April 17, 2023

Subject: Revised Additional Vapor Mitigation System Commissioning Plan for Community Within the Corridor – West Block 3212 W. Center St., 2727 N. 32nd St., and 2758 N. 33rd St., Milwaukee, WI 53210 BRRTS #: 02-41-587376, FID #: 341333190

> Subject: Technical Assistance Provided – Review of Additional Commissioning Plan Community Within the Corridor – West Block
> 3212 W. Center Street, 2727 N. 32nd Street, & 2758 N. 33rd Street, Milwaukee, WI BRRTS #02-41-587376, FID #341333190

- Figure 1 Table 1 Subslab Depressurization Measurement Locations
- Results of Passive Air Sampling
- WDNR Correspondence Attachment A
- Air Sampling Locations Attachment B
- PE Certification Attachment C

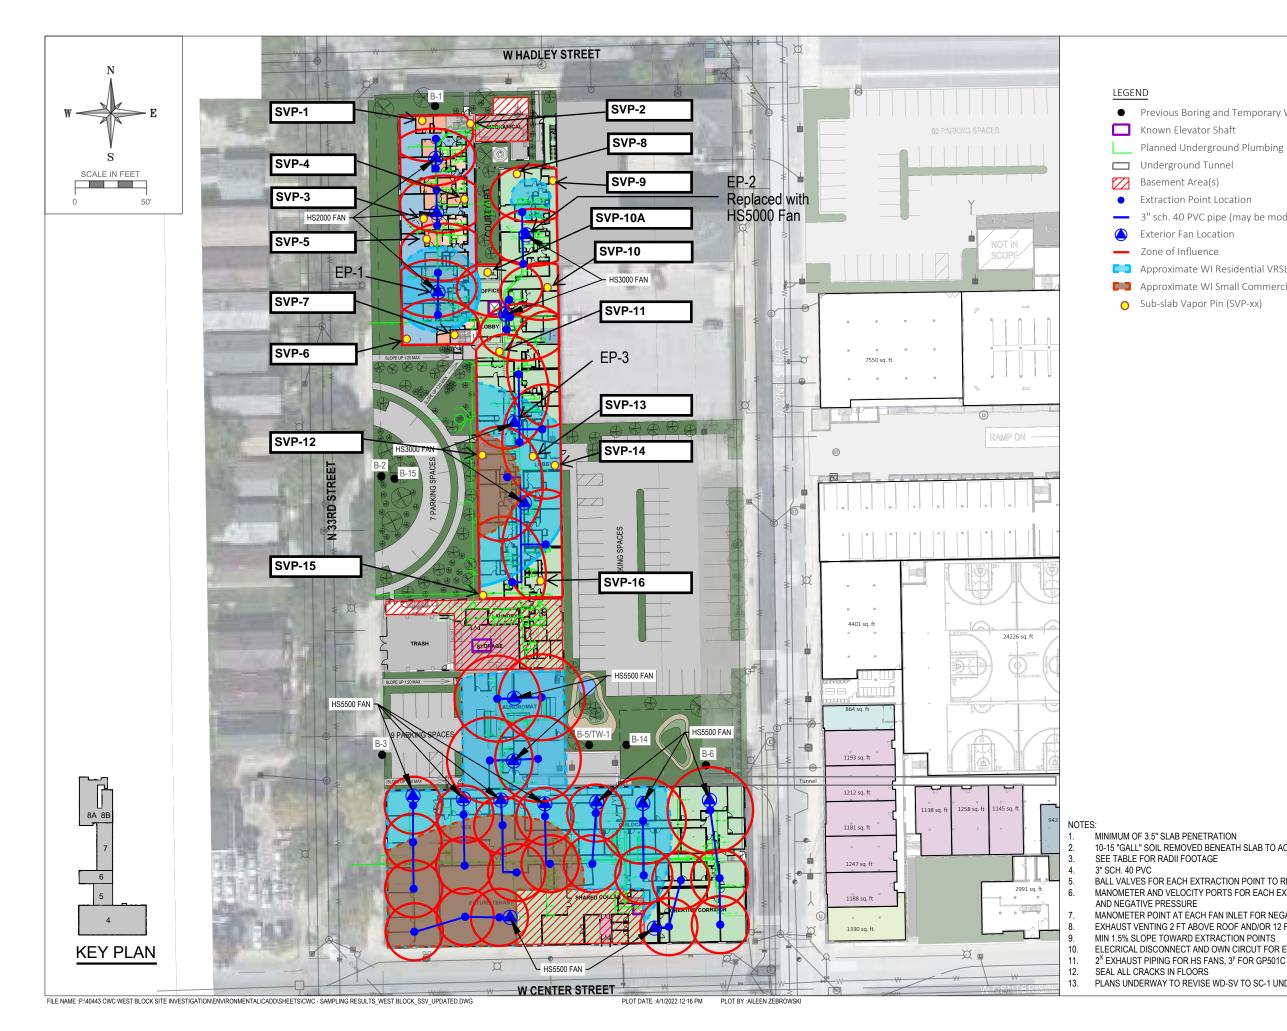
2. Per Wis. Admin. Code § NR 724.13(1)(d), all pressure field extension (PFE) points (SVP-1 to SVP-16) should be re-measured concurrently with the additional passive indoor air sampling. It appears that, over the first three rounds of commissioning, the PFE results have generally diminished in magnitude and are now approaching the minimum recommended differential negative pressure of 0.004 inches H2O.

- 2. Per Wis. Admin. Code § NR 724.13(1)(d), all pressure field extension (PFE) points (SVP-1 to SVP-16) should be re-measured concurrently with the additional passive indoor air sampling. It appears that, over the first three rounds of commissioning, the PFE results have generally diminished in magnitude and are now approaching the minimum recommended differential negative pressure of 0.004 inches H₂O.

We will perform PFE testing as requested. We note that the PFE readings previously measured followed the expected seasonal variation with the lowest readings occurring during heating season. If PFE readings are measured not meeting the -0.004 inches of water depressurization standard, the fan capacity will be adjusted, turning up the speed on adjustable fans or upgrading the fan capacity with larger fans, as necessary.

- Work is scheduled for the week of April 23, 2023.
- One round of sub-slab vacuum measurements will be performed at locations SVP-1 to SVP-16 on the ground floor of buildings 6, 7, 8A, and 8B. The locations of the proposed measurements are included on Figure 1.

Air Sampling Locations

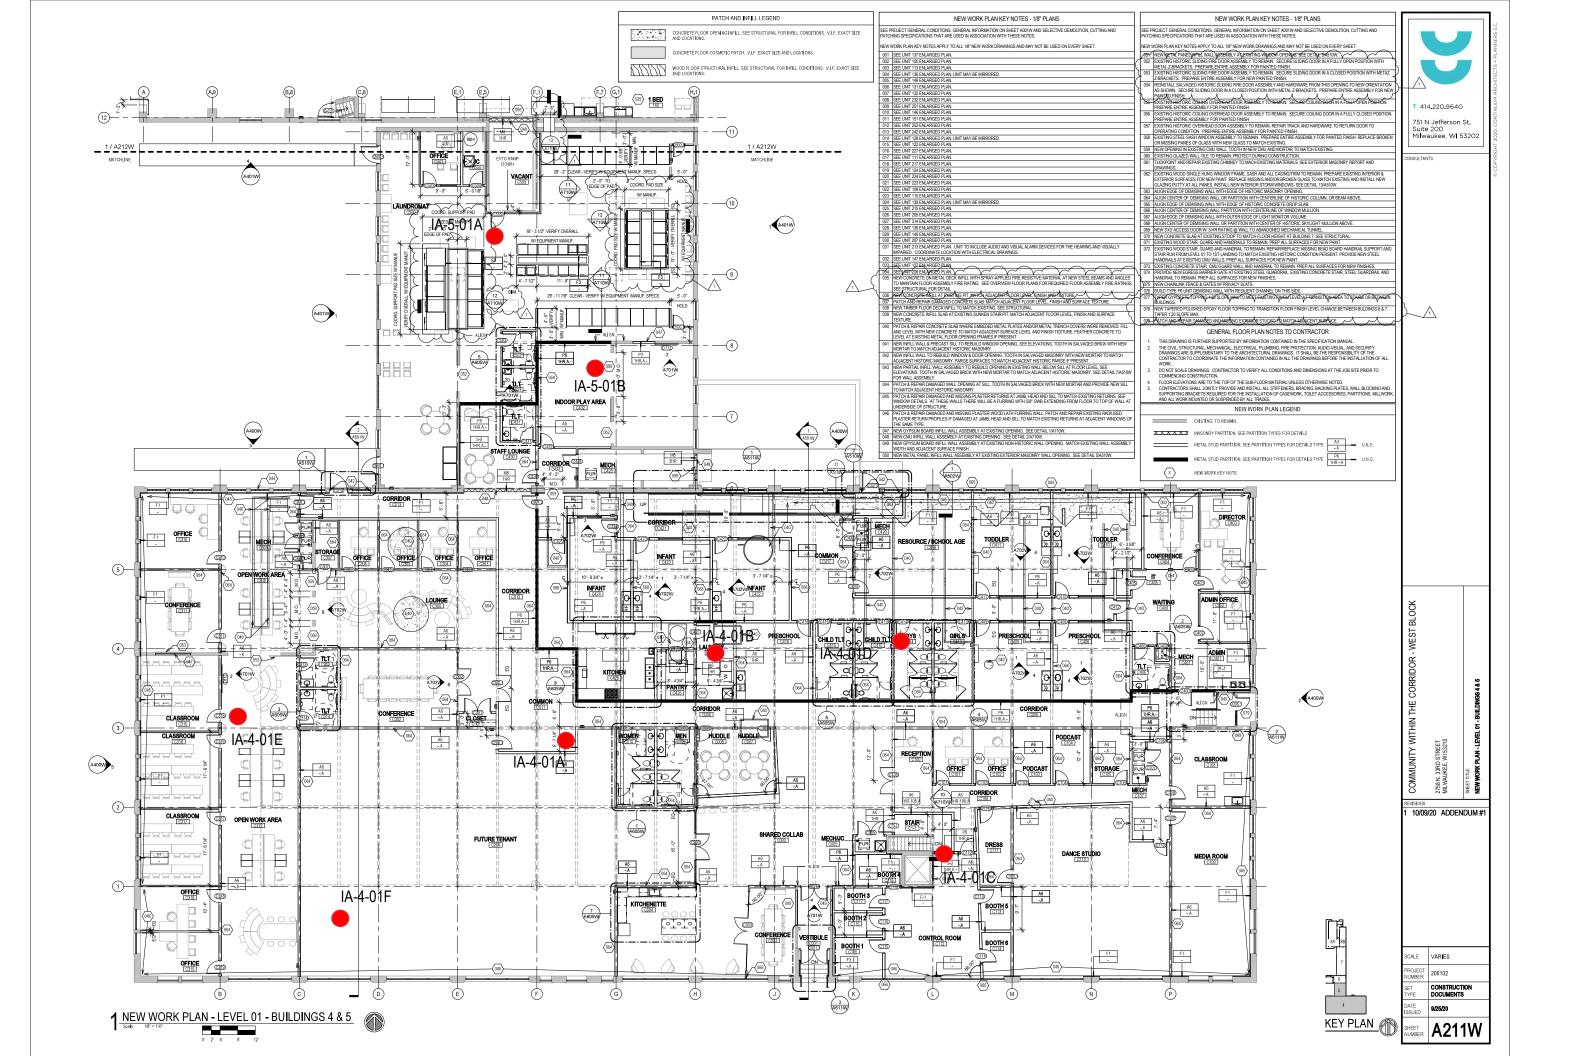
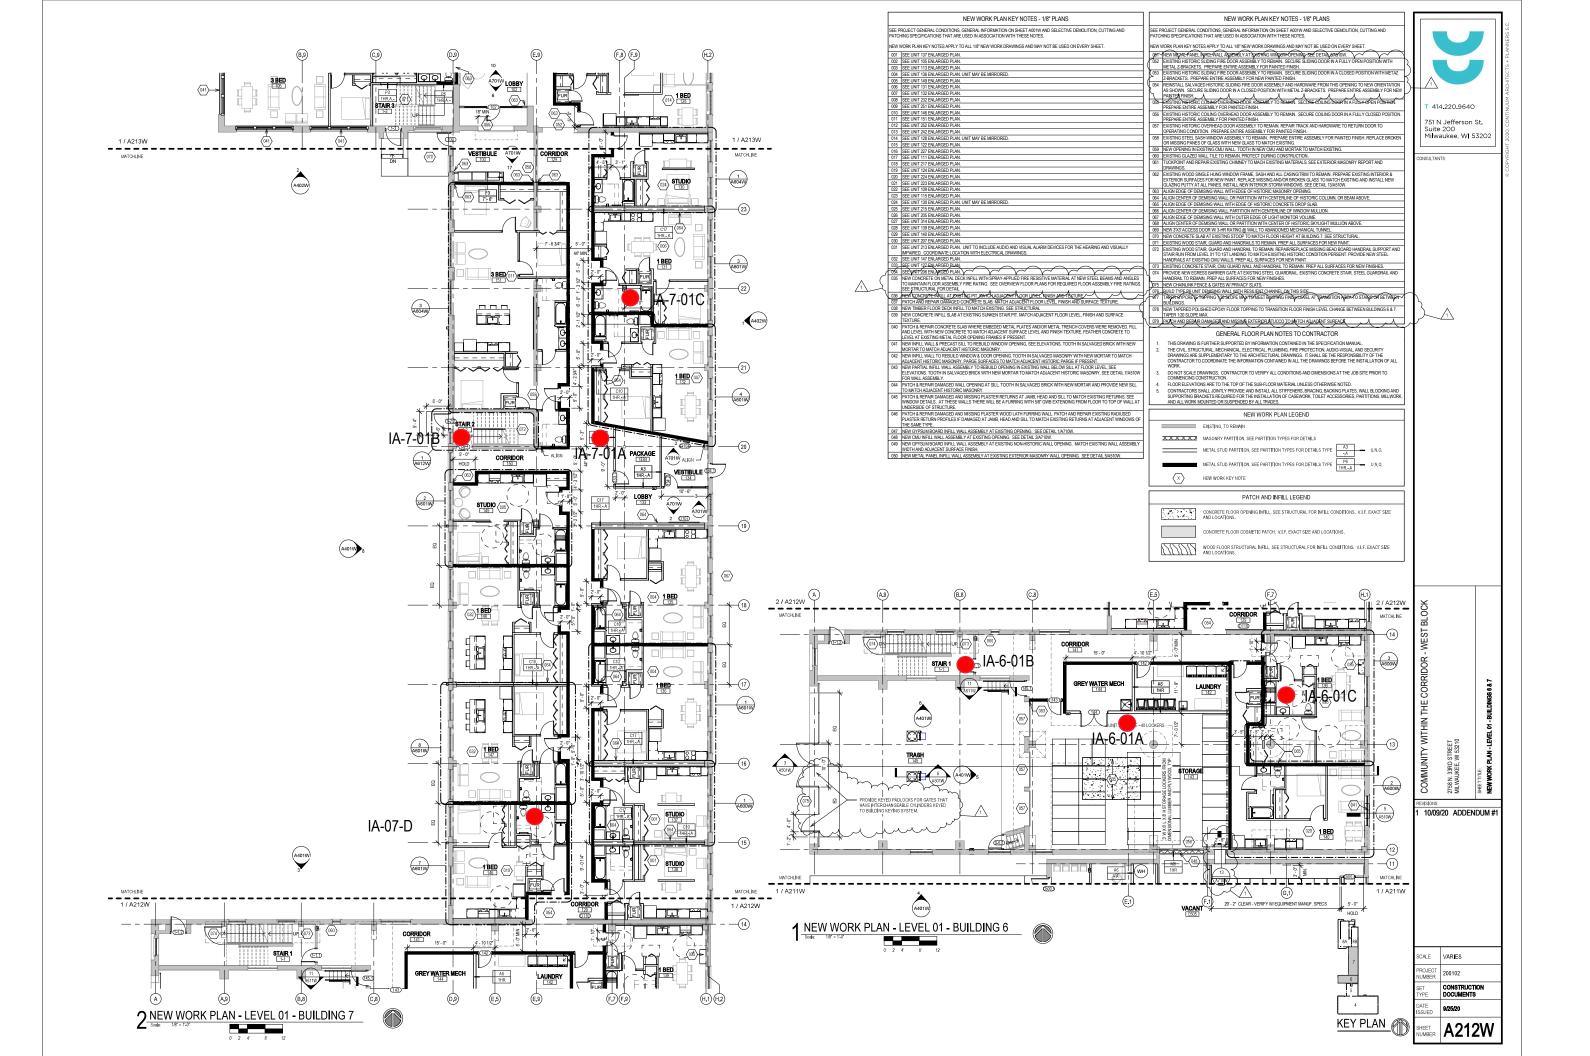
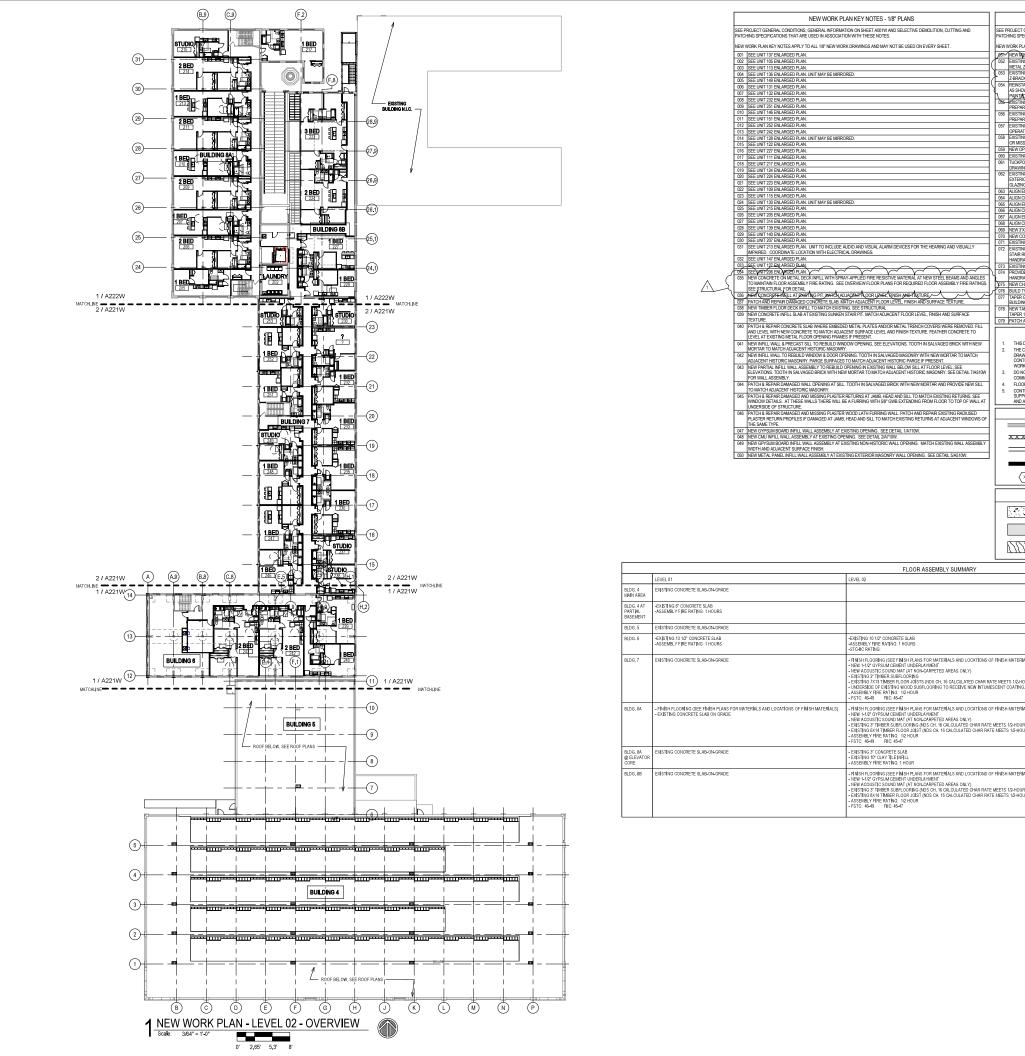
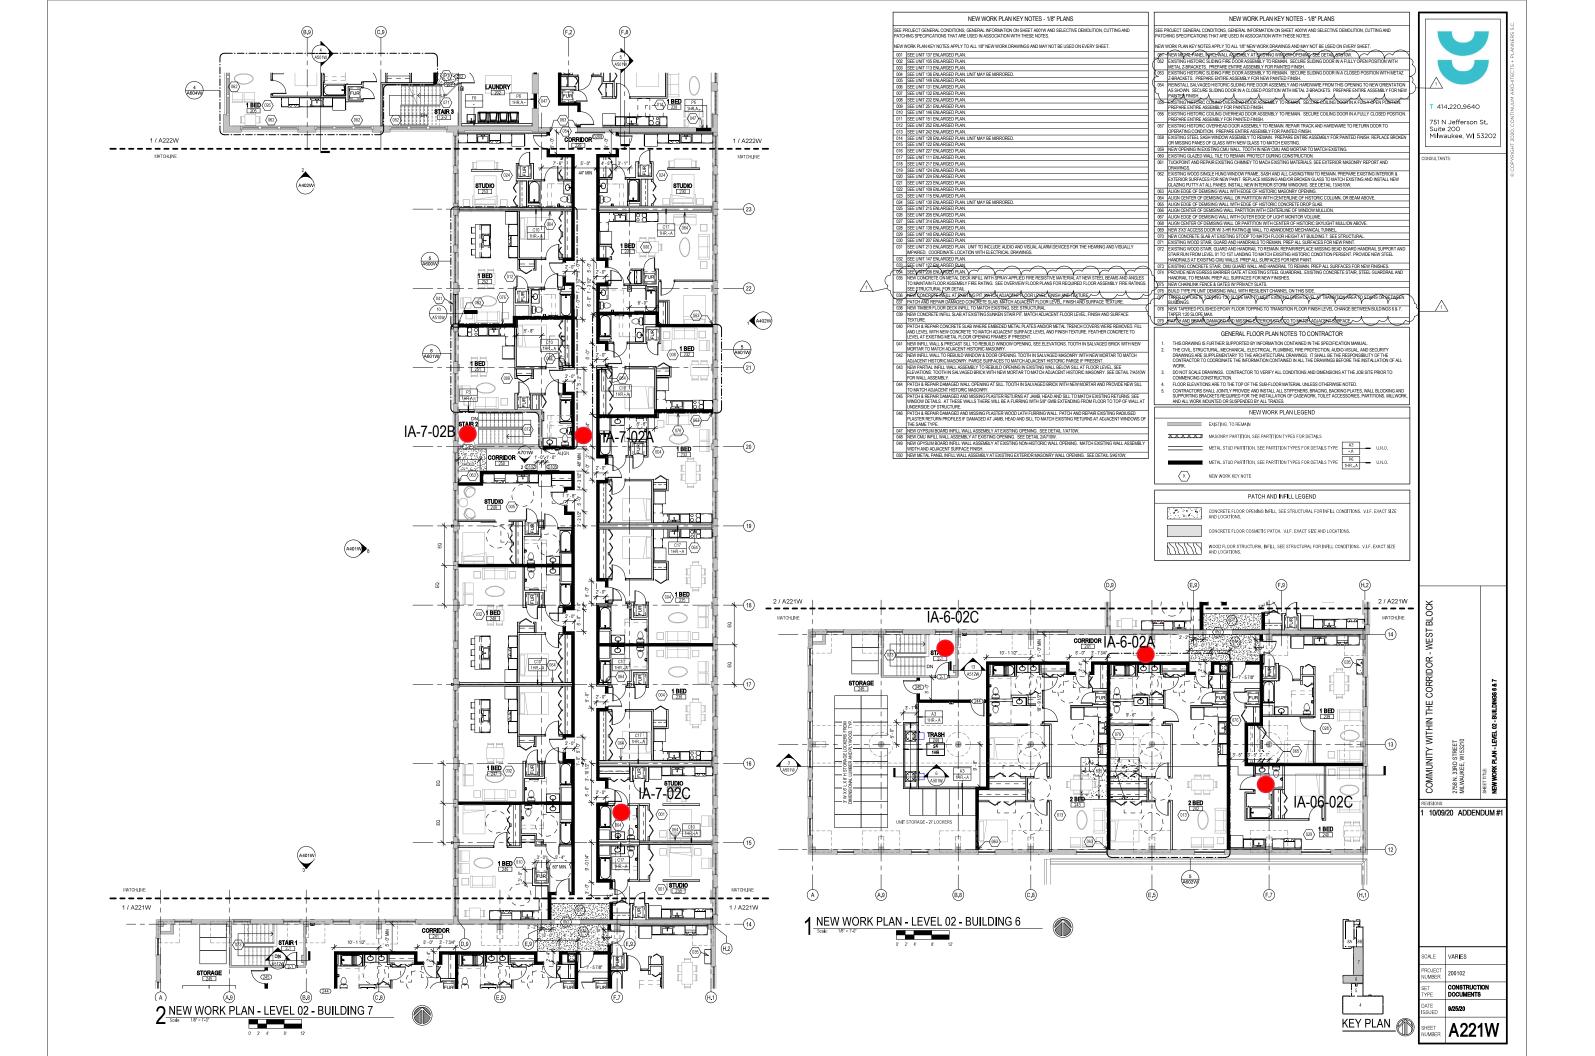
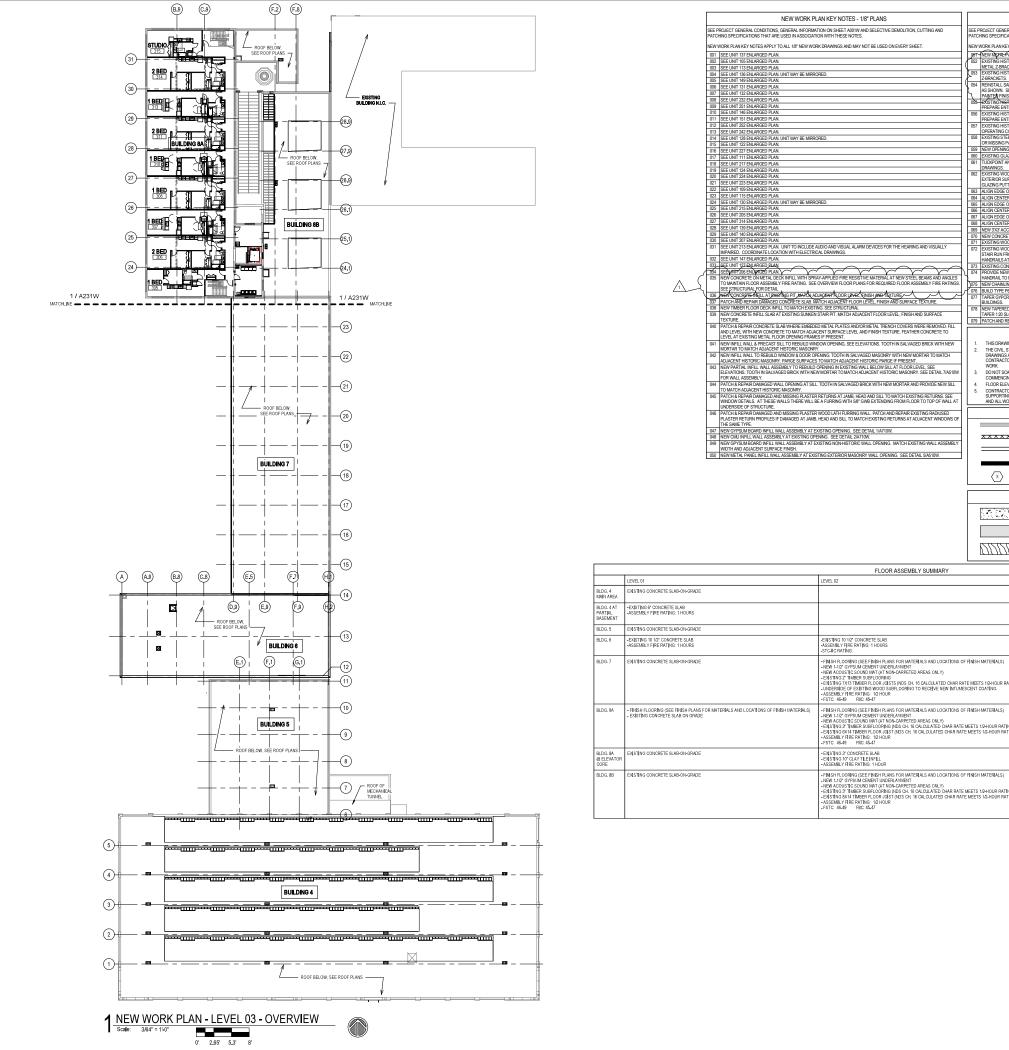
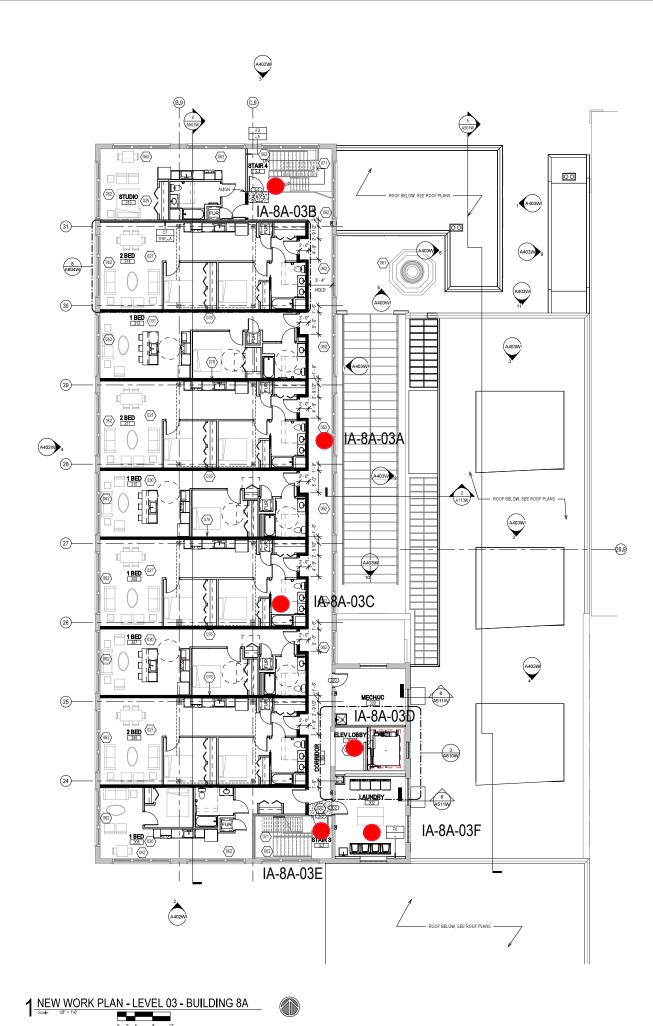
Per Wis. Admin. Code § NR 726.13(1)(b), the DNR may not close a case if the remaining level of contamination is likely to cause a VAL in indoor air to be attained or exceeded. Further, per Wis. Admin. Code § NR 722.09(2)(d), where a discharge of volatile hazardous substances has occurred, such as trichloroethylene (TCE), one of the contaminants of concern at the site, the vapor intrusion pathway shall be evaluated to determine the likelihood of those substances entering the breathing space of a structure. To demonstrate these administrative code requirements are met, all indoor air sample locations throughout Buildings 6, 7, 8A, and 8B (IA-6-01A to IA-8B-02D) should be re-sampled using passive samplers, as the previous commissioning rounds detected TCE just below the residential VAL at several sample locations.

- Per Wis. Admin. Code § NR 726.13(1)(b), the DNR may not close a case if the remaining level of contamination is likely to cause a VAL in indoor air to be attained or exceeded. Further, per Wis. Admin. Code § NR 722.09(2)(d), where a discharge of volatile hazardous substances has occurred, such as trichloroethylene (TCE), one of the contaminants of concern at the site, the vapor intrusion pathway shall be evaluated to determine the likelihood of those substances entering the breathing space of a structure. To demonstrate these administrative code requirements are met, all indoor air sample locations throughout Buildings 6, 7, 8A, and 8B (IA-6-01A to IA-8B-02D) should be re-sampled using passive samplers, as the previous commissioning rounds detected TCE just below the residential VAL at several sample locations.

We acknowledge WDNR's concerns and will endeavor to address them during the next round of sampling. However, as TCE is heavier than air with a molecular weight of 131.39, and no TCE has ever been detected in the facility above ground level based on three previous rounds of testing, we therefore are proposing to modify the plan by proposing to perform no passive sampling on levels 2 and 3 of Buildings 6, 7, 8A, and 8B. To allay WDNR concerns, we are proposing to instead collect 19 discrete samples on Levels 2 and 3 and report the results based on portable gas chromatograph (GC) analysis.

- One round of passive air sampling at locations is proposed for April 2023. The passive sample locations include OA-6/7/8A/8B-Background, IA-6-Basement, IA-8A-Basement, IA-6-01A, IA-6-01B, IA-6-01C, IA-7-01A, IA-7-01B, IA-7-01C, IA-7-01D, IA-8A-01A, IA-8A-01B, IA-8A-01C, IA-8A-01D, IA-8B-01A, IA-8B-01B, IA-8B-01C, and IA-8B-01D for a total of 15 locations on the ground floor and in the basement of buildings 6, 7, 8A, and 8B. The locations of the proposed samples are shown in Attachment B.

- Portable GC test locations are proposed for IA-06-02A, IA-06-02B, IA-06-02C, IA-7-02A, IA-7-02B, IA-7-02C, IA-8A-02A, IA-8A-02B, IA-8A-02C, IA-8A-02D, IA-8B-02A, IA-8B-02B, IA-8B-02C, IA-8B-02D, IA-8A-03A, IA-8A-03B, IA-8A-03C, IA-8A-03D, IA-8A-03E, and IA-8A-03F. 19 portable GC discrete samples are proposed in total on the 2nd and 3rd floors of buildings 6, 7, 8A, and 8B. Discrete sample results will be provided to WDNR within 10 days of collection and additional samples will be collected at WDNR request. The locations of the proposed samples are included in Attachment B.
